MEMORANDUM

FOR THE MEMBERS OF THE TECHNICAL REVIEW COMMITTEE (TRC) FOR  
INSTALLATION RESTORATION PROGRAM AT NAVAL WEAPONS INDUSTRIAL RESERVE  
PLANT (NWIRP) BETHPAGE, NEW YORK

**PROPOSED REMEDIAL ACTION PLAN  
FOR  
SITES 1, 2 & 3  
NWIRP BETHPAGE, NEW YORK**

COMMENTS AND NAVY RESPONSES  
ON  
PROPOSED REMEDIAL ACTION PLAN - SITES 1, 2, 3  
NWIRP BETHPAGE, NY

FIGURE 11

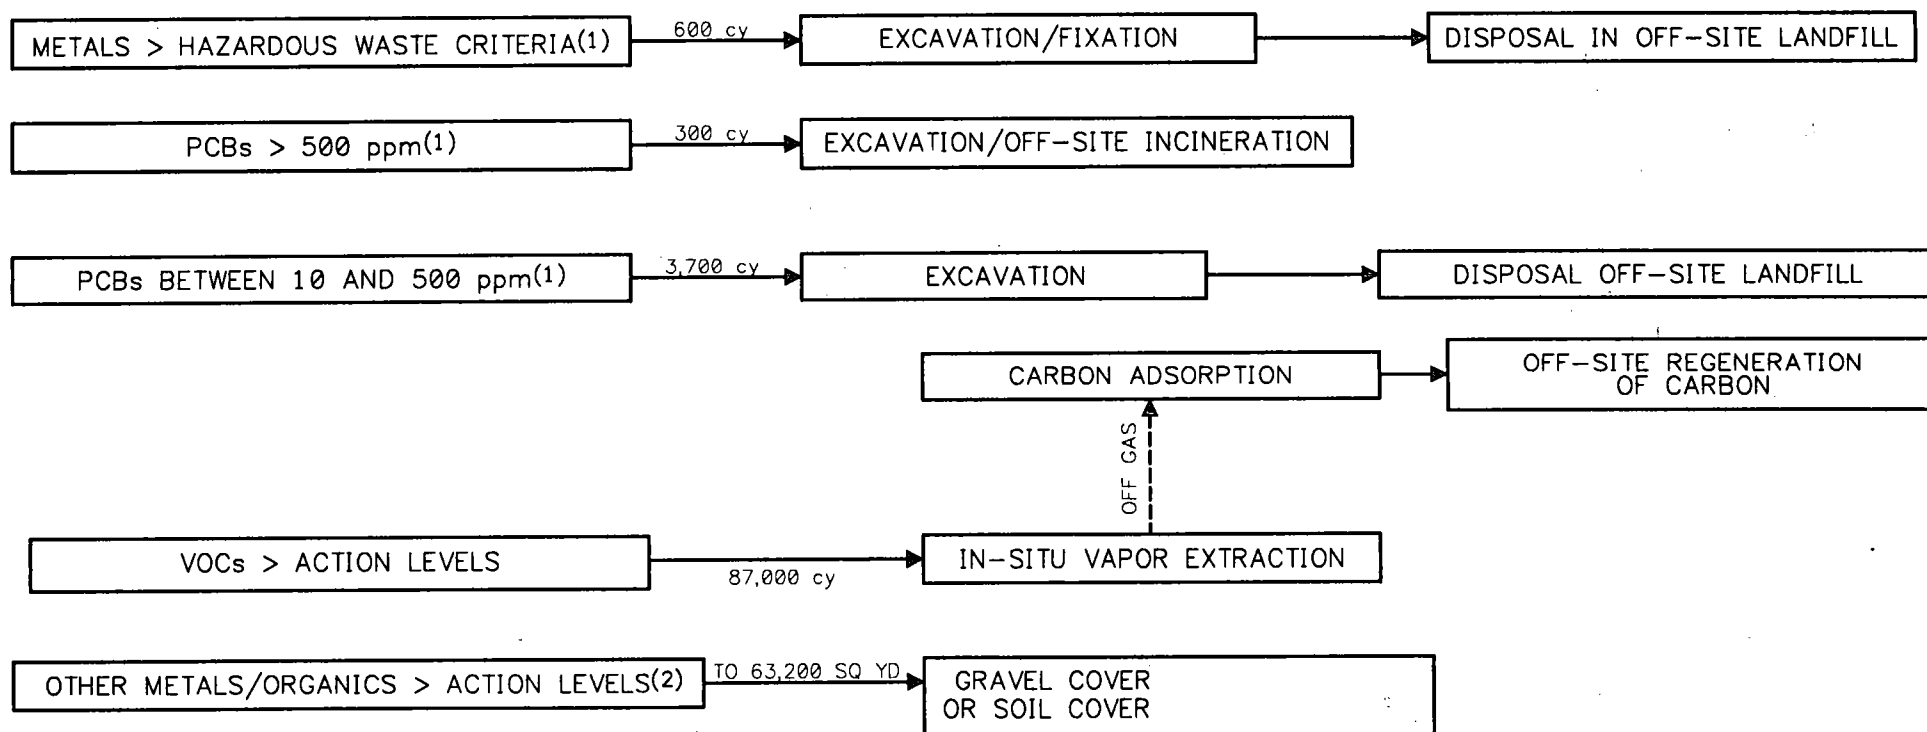
9. Comment: Page 34 - The summary of the preferred alternative should include a bullet stating that the on-site areas which still exceed remedial action objectives will be managed by a cover and deed restrictions.

Response: This section has been rewritten to more clearly define the steps required to implement the preferred remedy. Also, a Table 3 on pages 38 through 40 has been added to show each chemical and the technology which will be used to address each chemical depending on its concentration. This table is on a site-by-site basis.
